— REVISED SITE PLAN: MORE QUESTIONS —

Mill Plaza Redevelopment. 7 Mill Road. Continued review of application for site plan and conditional use for mixed-use redevelopment project, drive-through facility for bank, and activity within the wetland and shoreland overlay districts. Colonial Durham Associates, property owner....Central Business District. Map 5, Lot 1-1.

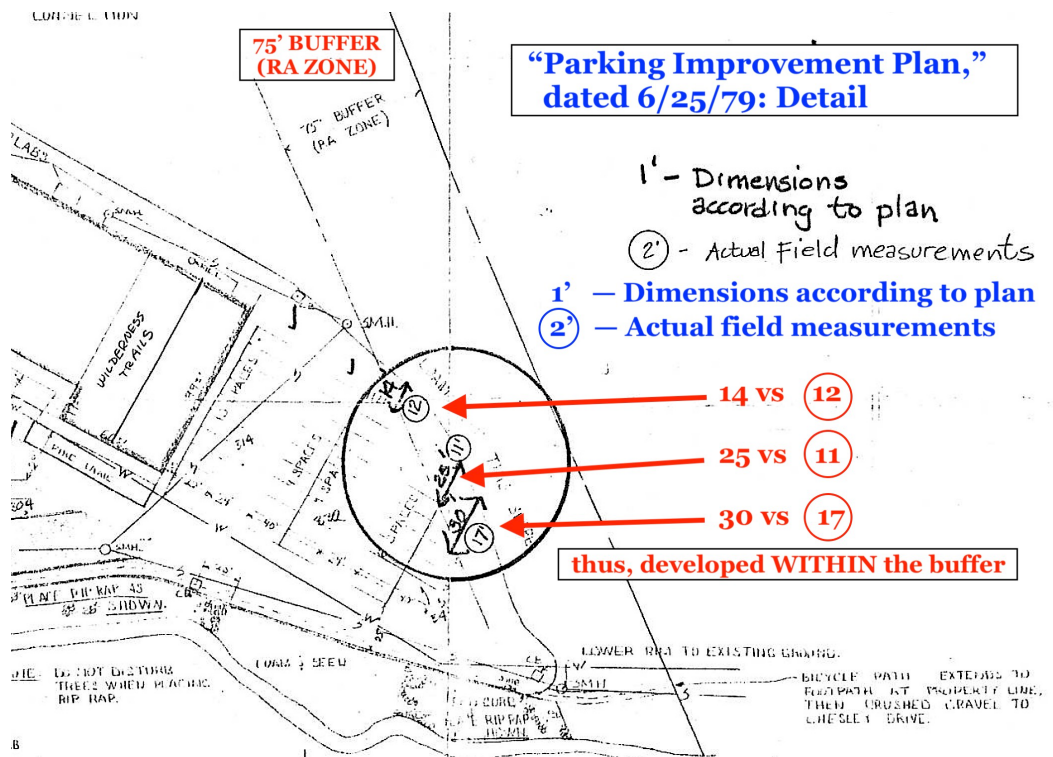
A Planning Board letter dated May 1, 1978 refers to having approved a revised site plan dated April 26, 1978. It turned out that that plan showed a section of College Brook located in the wrong place, leading to construction closer to the brook.

(Public Works Director George Crombie wrote to the developer on October 17, 1978: “Due to the fact that the [former engineer’s] plan showed the brook in the wrong location, **your present engineer had to redesign the parking lot closer to the brook than was originally anticipated....**” See the highlights on the detail from the plan, below. Note: The colored markings are on the original, not mine.)

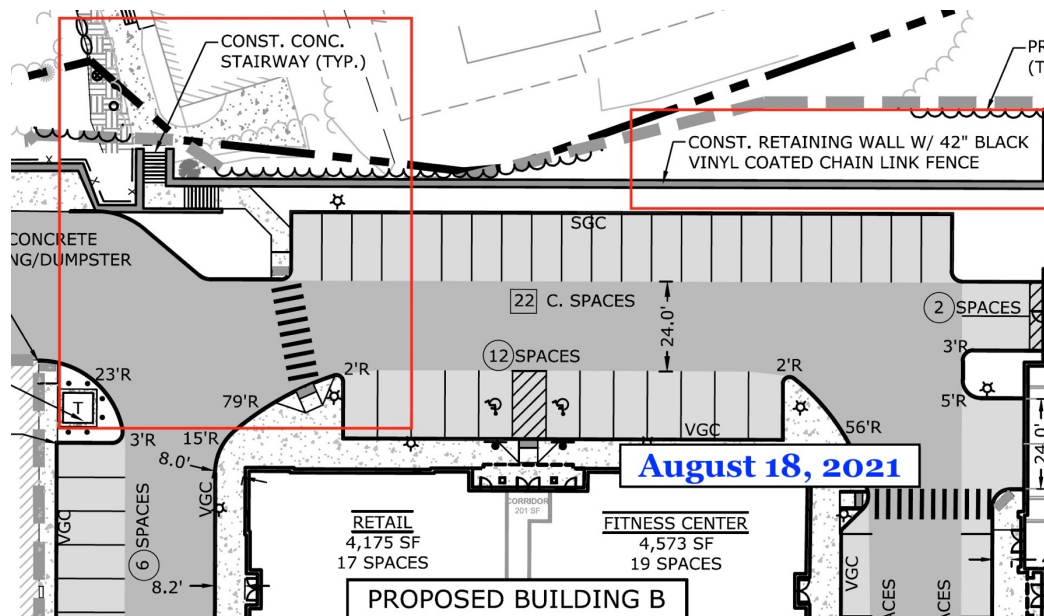
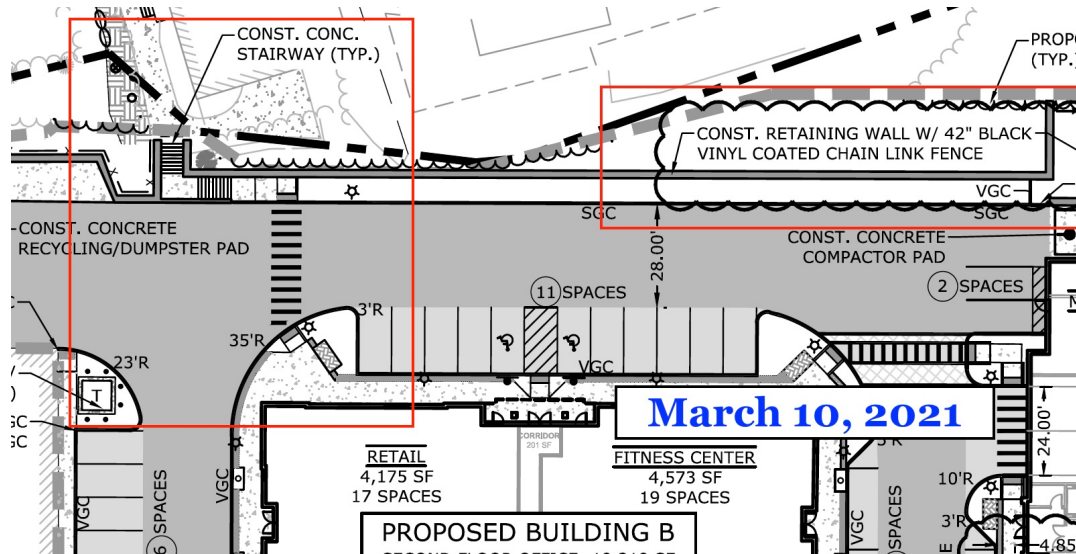
Residents have already testified that the amount of commercial parking proposed—in excess of that required—is excessive, as well as noted related Site Plan Regulations.

Who is going to park in the 22 spaces added between Building B and the hillside to Orion/Main Street—or in the 10 spaces at the very southeastern corner of the site?
